**DRAINAGE LETTER
FOR
STERLING RANCH
SKETCH PLAN AMENDMENT**

Job No. 1183.34

PCD Project No. SKP-235

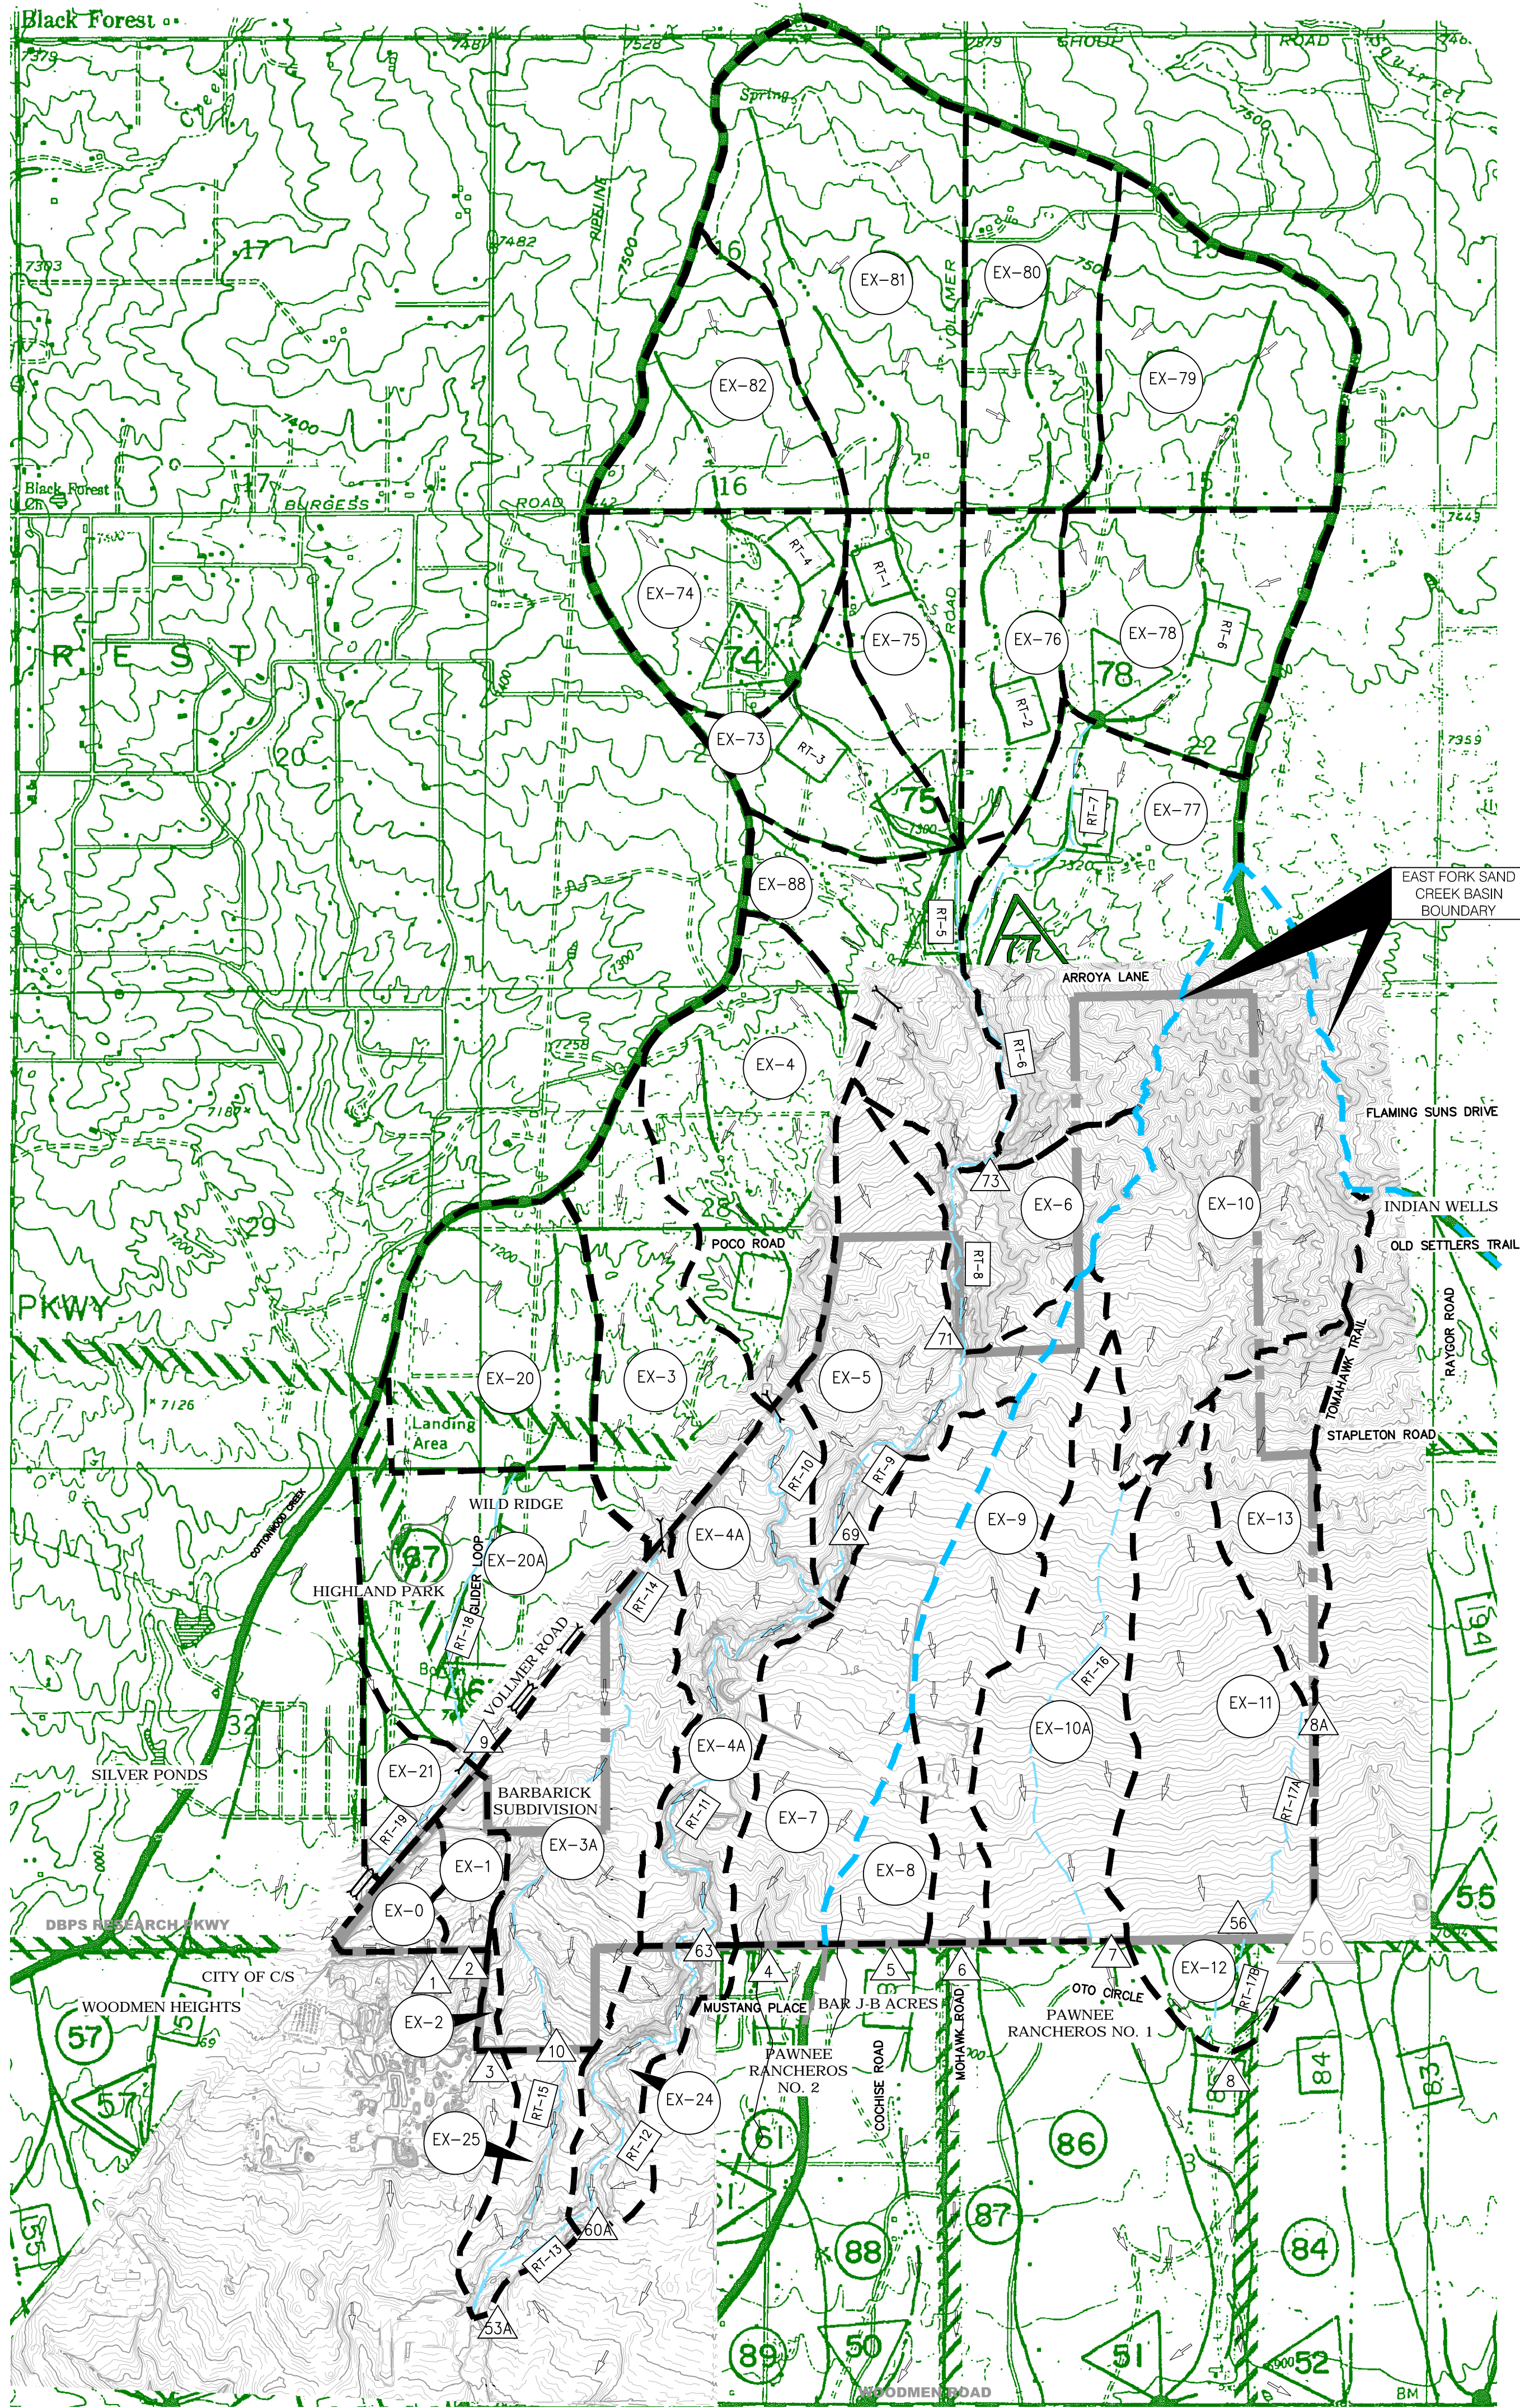
Unresolved:
Discuss impact to storm sewer system and trunk main in the basin from the increased density. State the change in peak flows at DP1E.
